# Field Sampling and Testing Plan

## Remedial Design Combe Fill South Landfill

State of New Jersey  
Department of Environmental Protection

Correspondence Regarding Comments on Field Sampling and Testing Plan

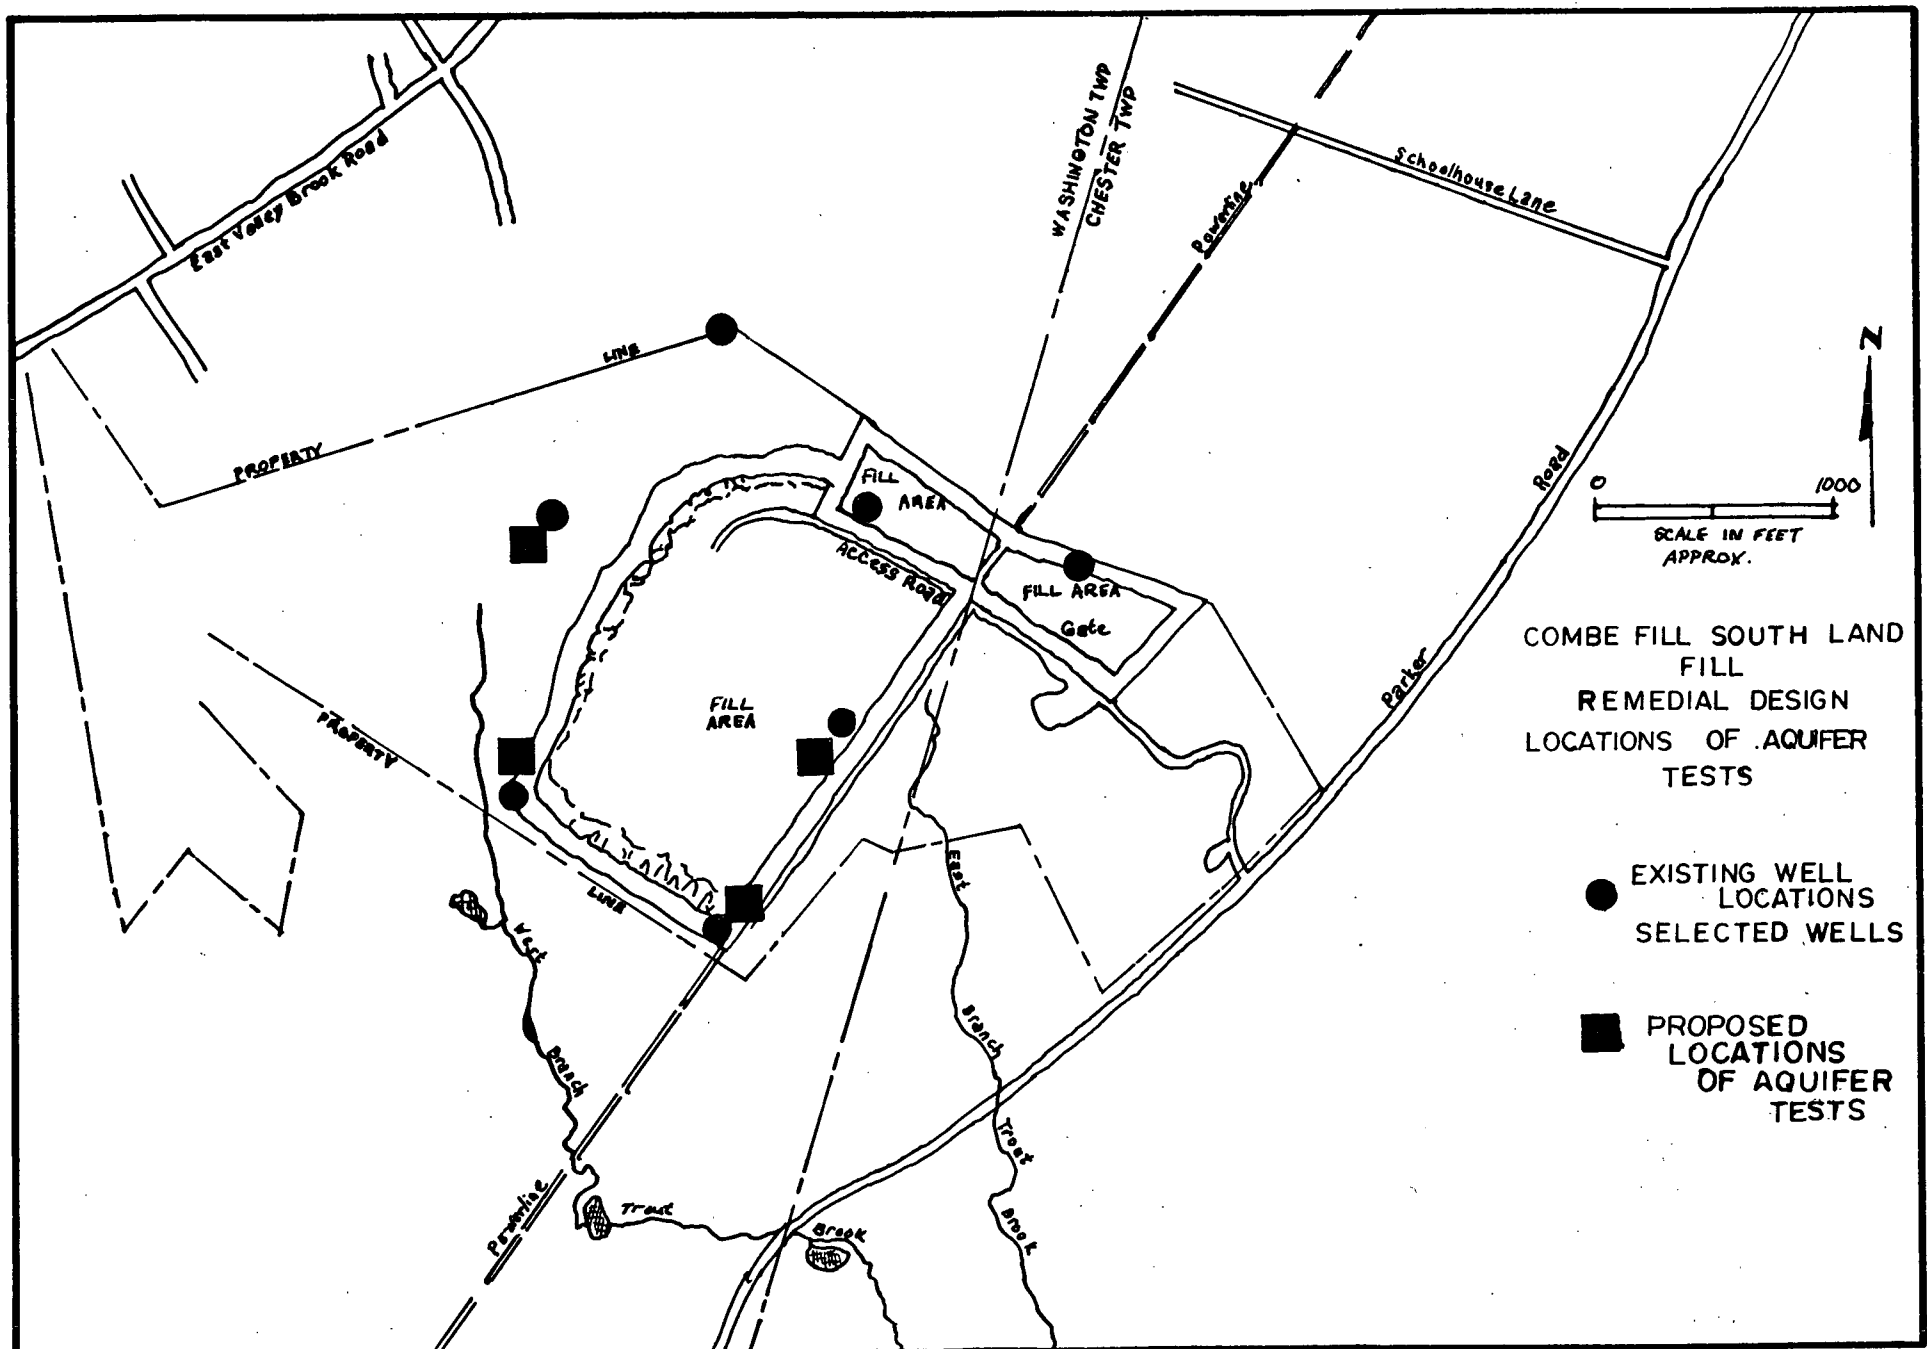
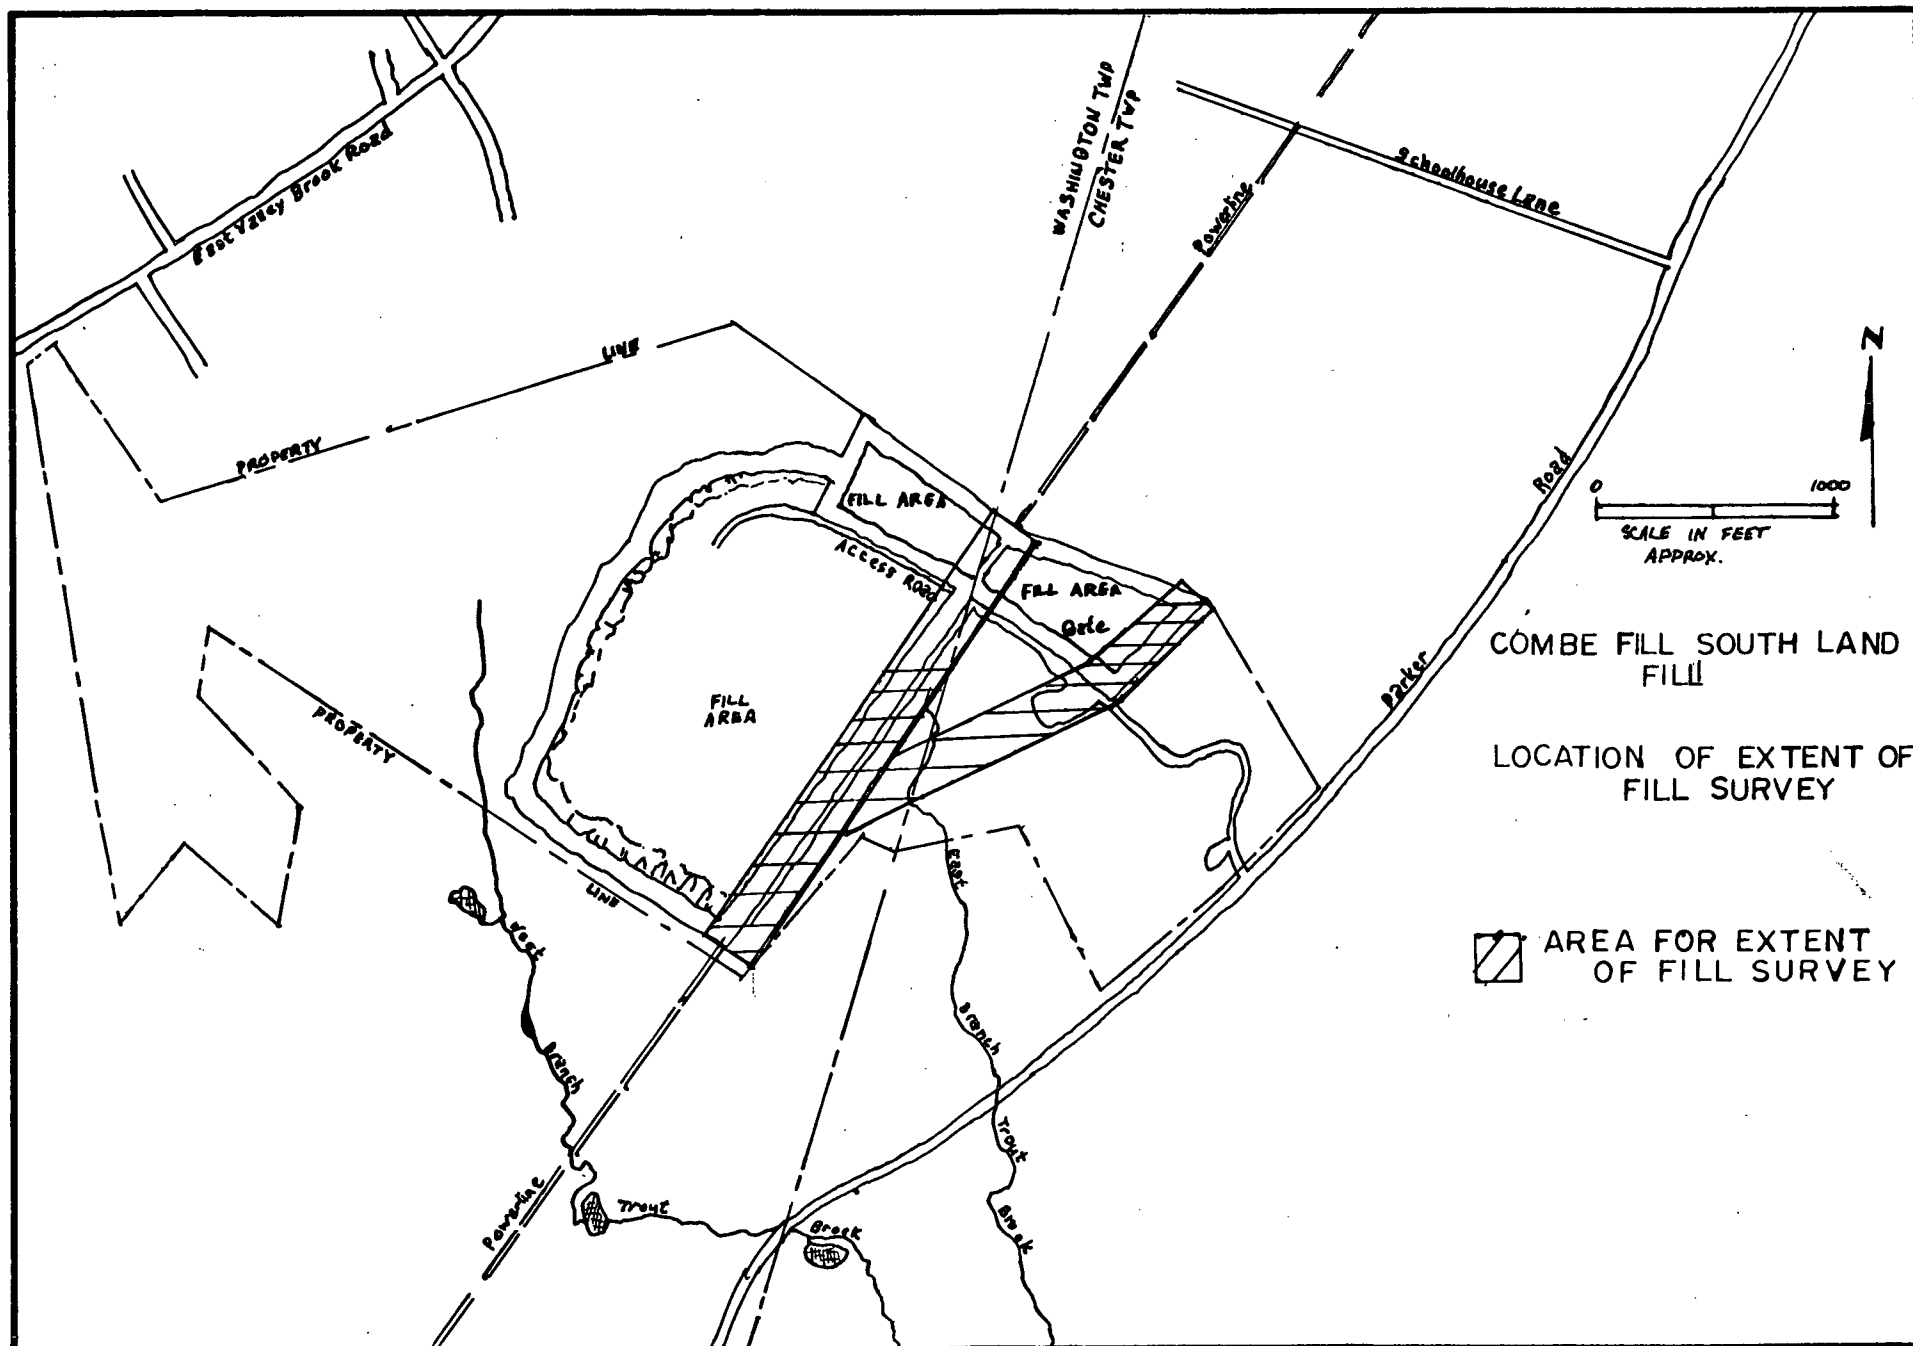
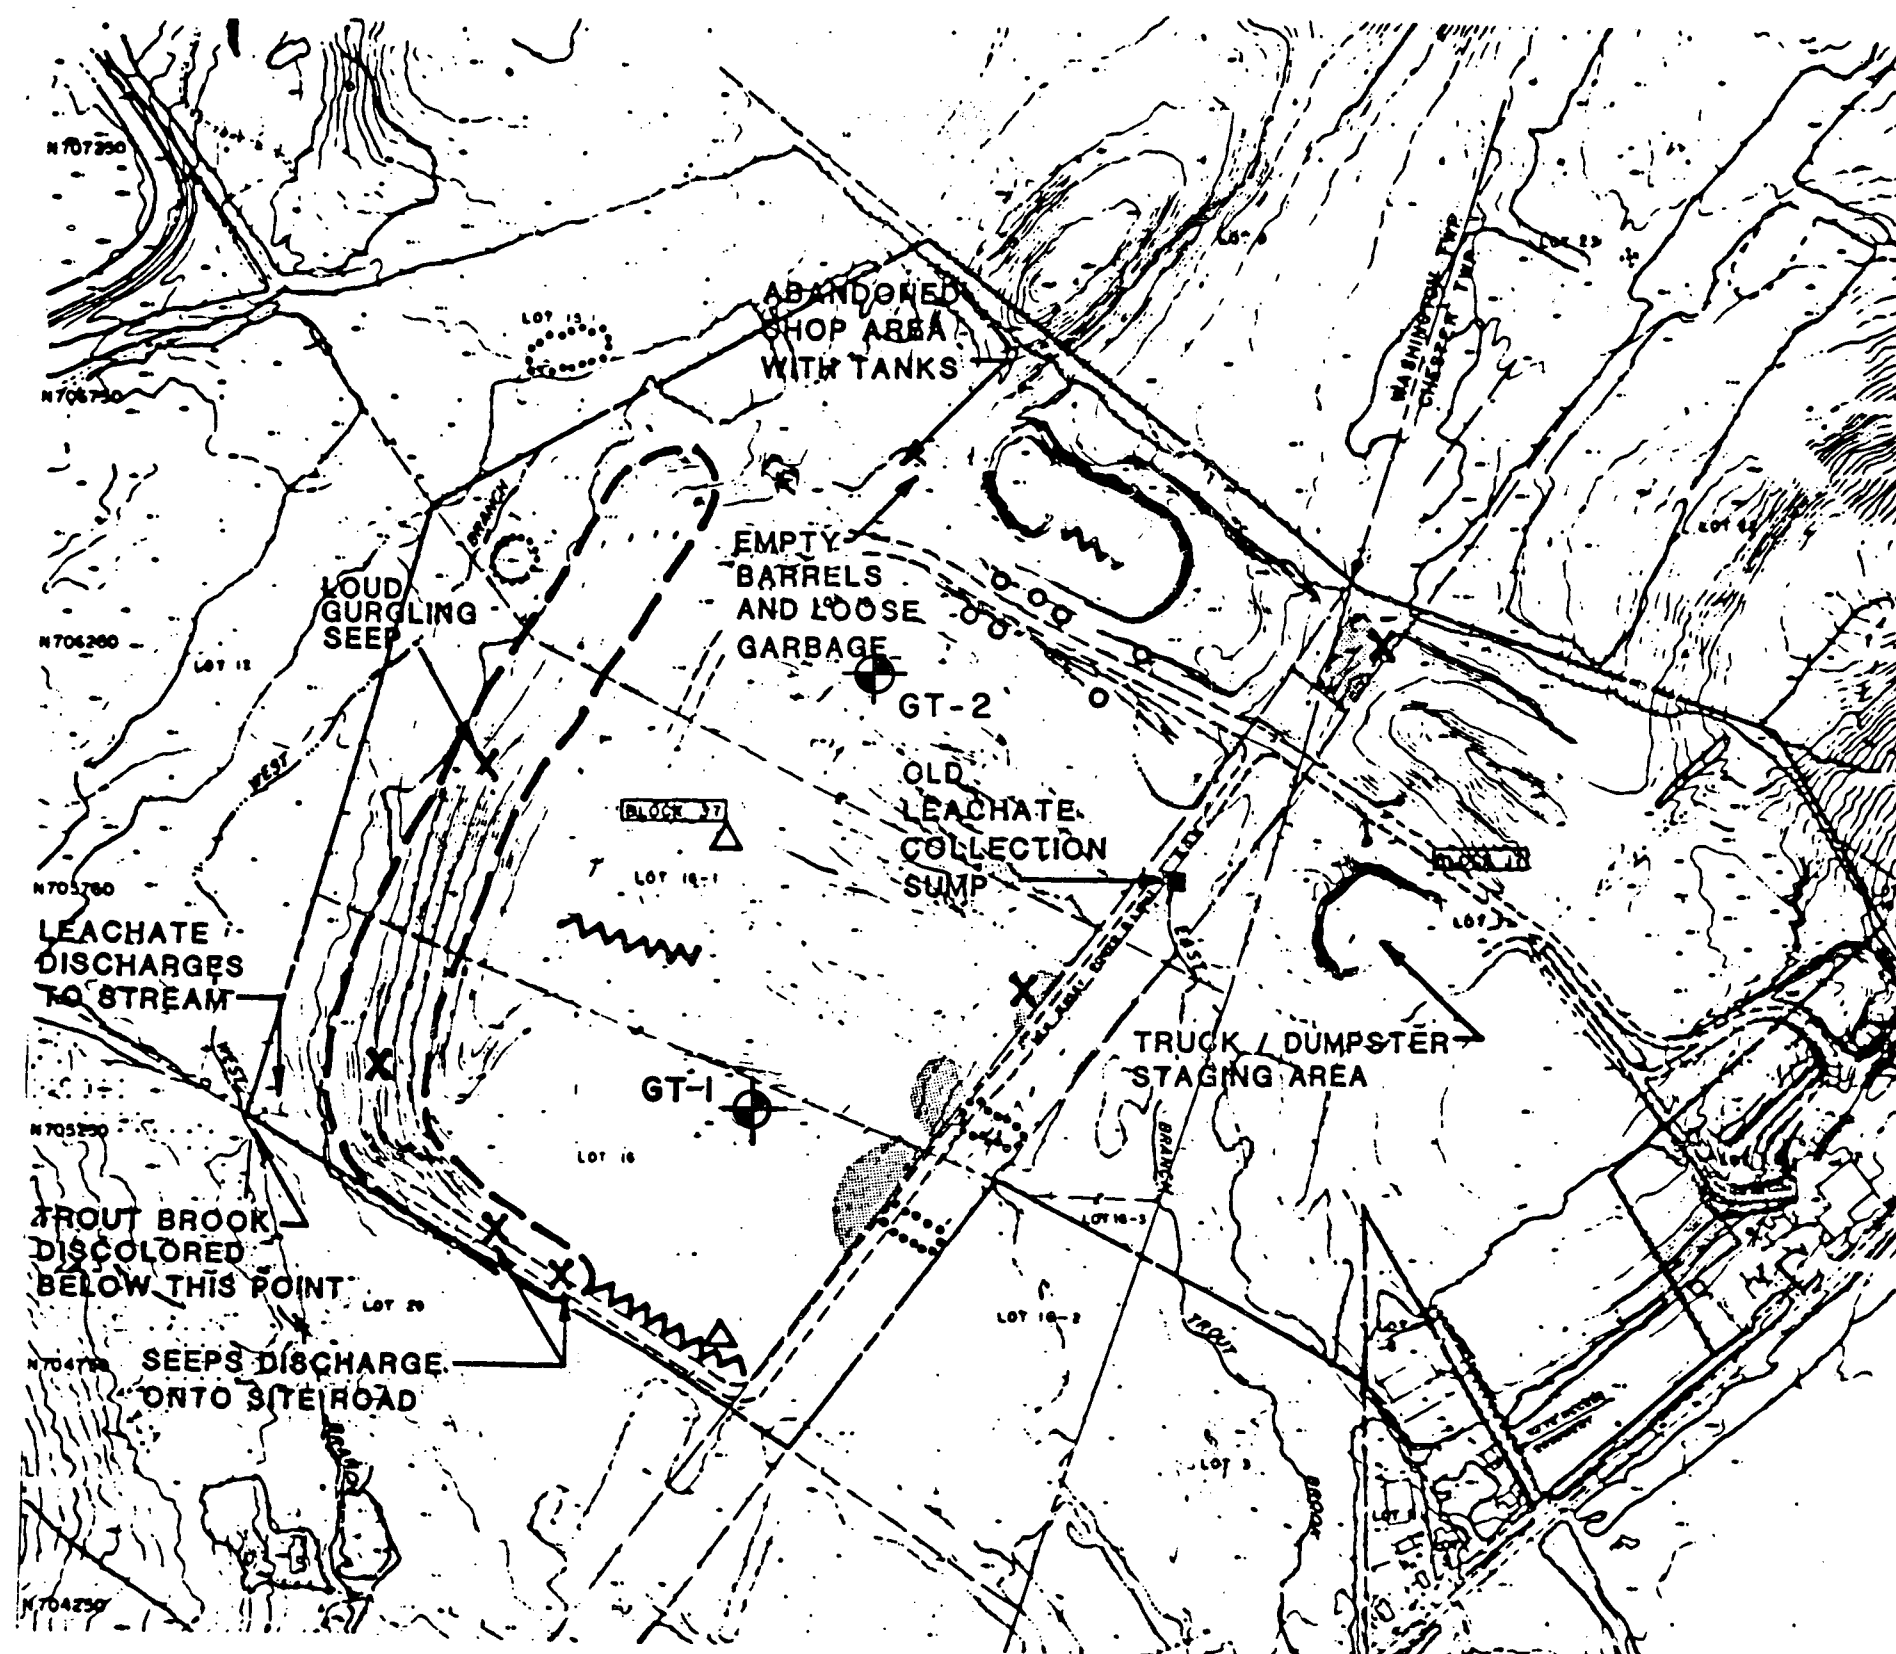
1. Figures 2, 4 and 5 are illegible. Please redo with all details legible and preferably on a somewhat larger scale. Identify site boundaries. Use appropriate line widths for reproduction at the intended scale. If contour lines in steep slope areas are too close together for legibility it may be helpful to interrupt the small interval lines and show only the emphasized lines in those areas.

Figure 6

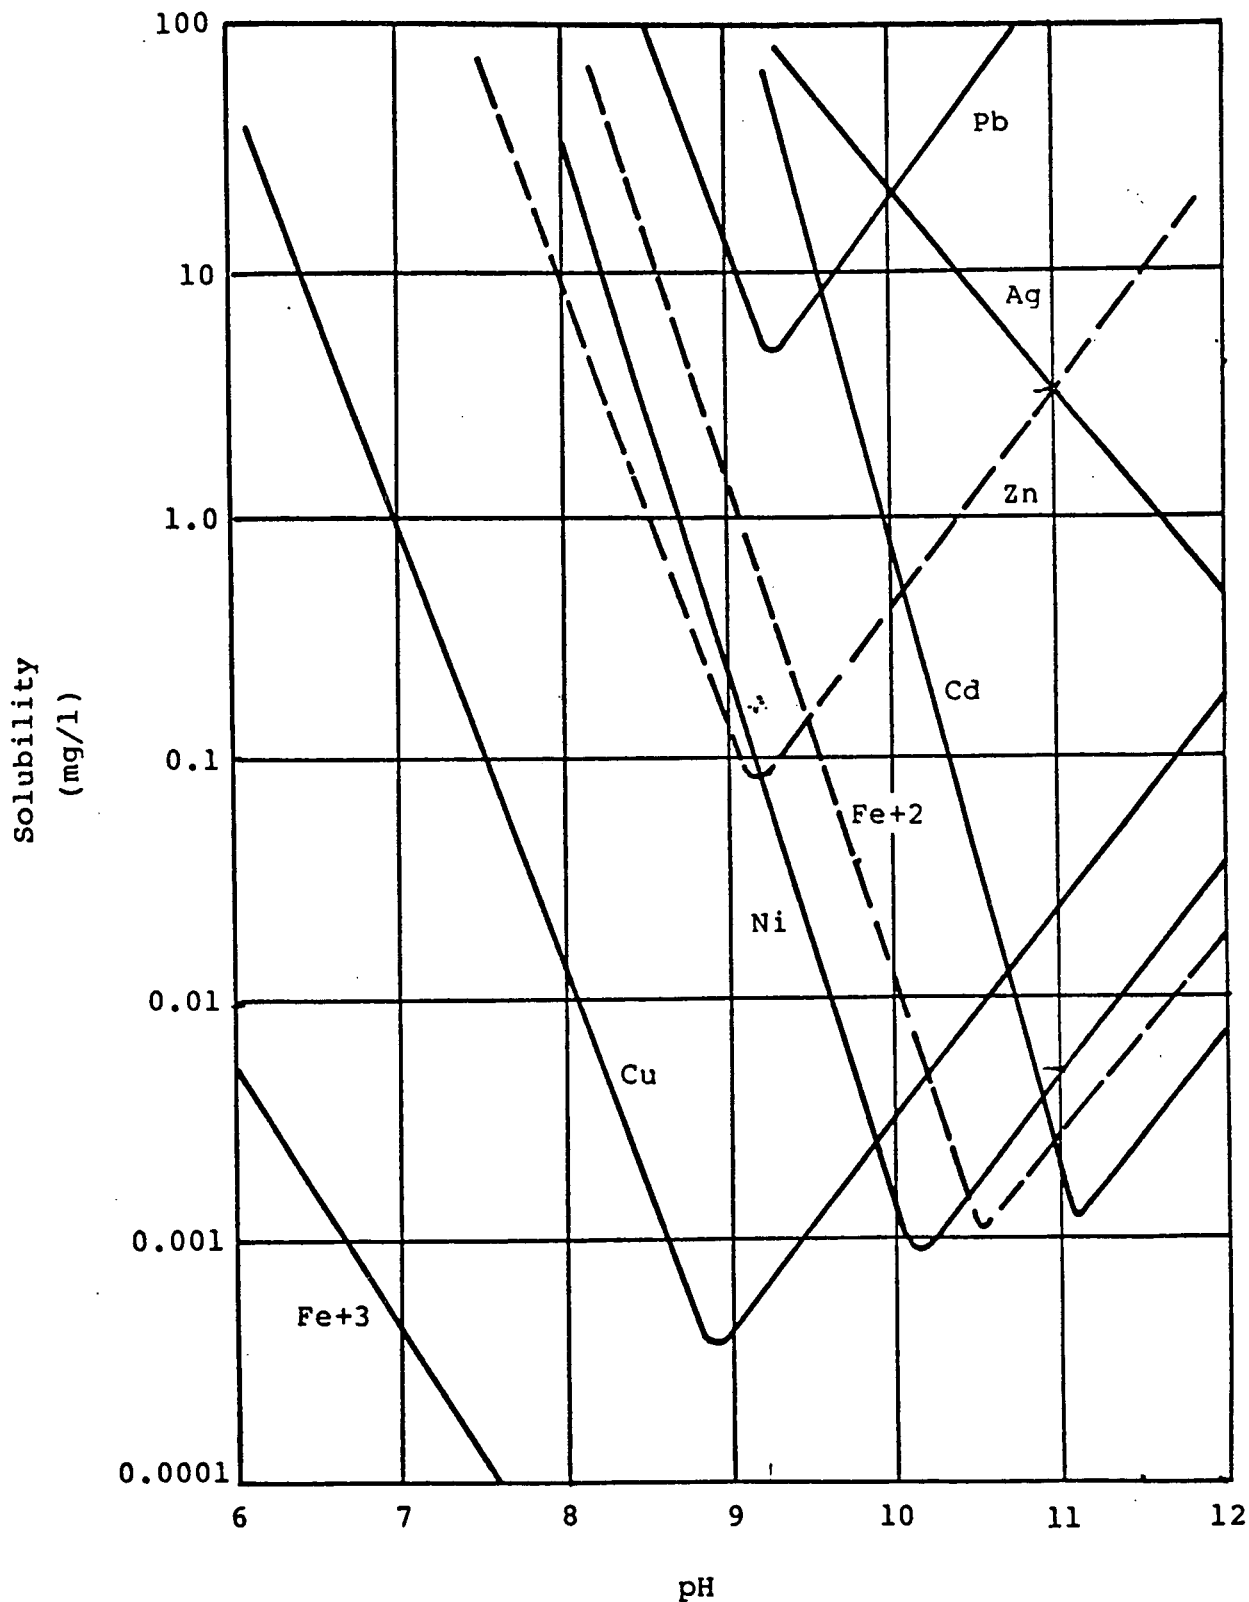
In Section 6.04, Bench Scale Testing, two typographical errors are present. The figure referred to in this section should be Figure 6, not Figure 7. An incorrect pH of 98.5 is also listed; this should probably be 9.5.
